Chanctonbury Landfill Action Group 3 (CLAG3) – Objection Report

January 2023

The Chanctonbury Landfill Action Group has prepared a detailed report explaining our objections to planning application WSCC/028/21 from Dudman (Rock Common) Limited and The Wiston Estate. This application is for working and processing sand from Rock Common Quarry; plus importing, treatment and landfill of imported material in the quarry void. This summary outlines our objections.

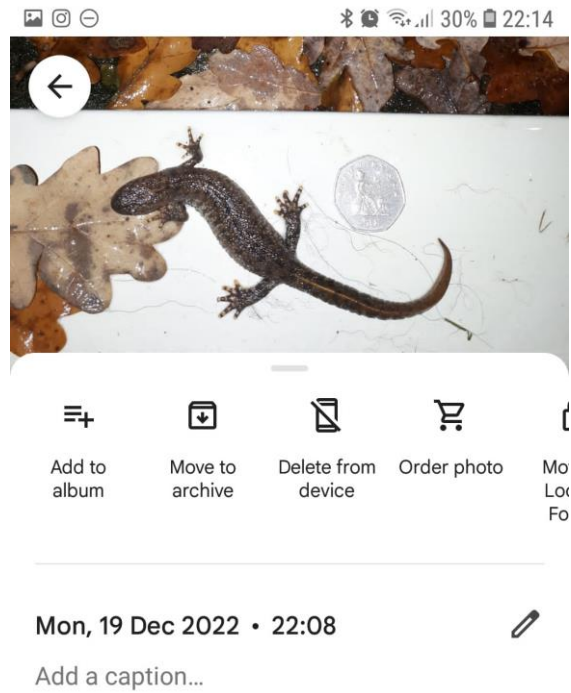
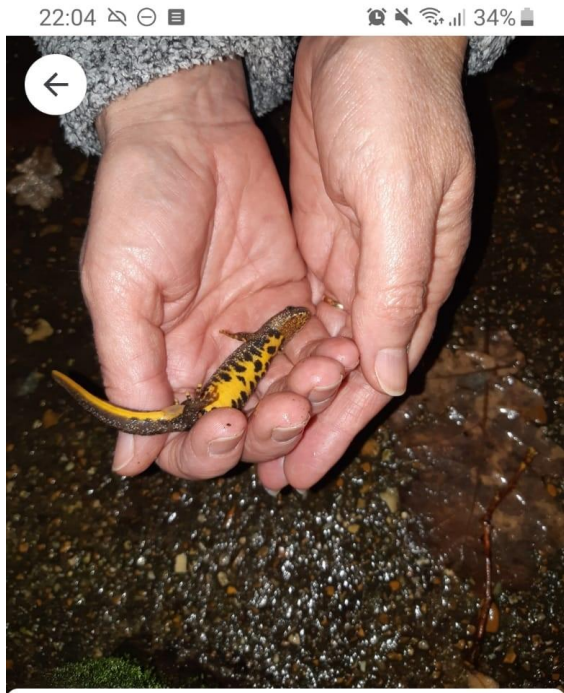
Leachate being processed and pumped back into the landfill site without monitoring or telemetry
